## RECALL SERVICE BULLETIN

DATE ISSUED	MODEL YEAR(S) AFFECTED	RSB #
3/22/2018	2018	515

Newmar Corporation has decided that a defect relating to motor vehicle safety exists in specific motorhomes. NHTSA #18V 144, TC # 2018-109

# HOW TO SECURE A 2018 ESSEX TAIL LIGHT ASSEMBLY

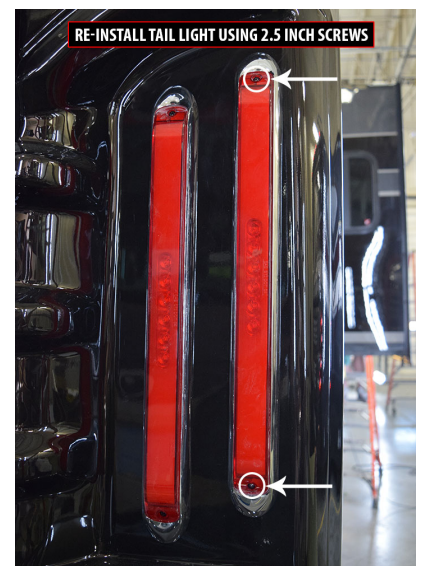
1. Remove the screws from the top and bottom of the outer tail light.

2. Install two stainless 2-1/2" screws from the bezel into the rear cap. Install them approximately one inch above the bottom hole and one inch below the top hole (as pictured). Do not over tighten these screws it will distort the taillight bezel.

3. Reinstall the tail light using stainless 2-1/2" self-tapping pan head screws.

4. Install a one inch self-tapping pan head screw into the top and bottom inside corner (as pictured).
5. Repeat the process for the tail light on the opposite side.
6. When finished, test the tail light/brake light operation.
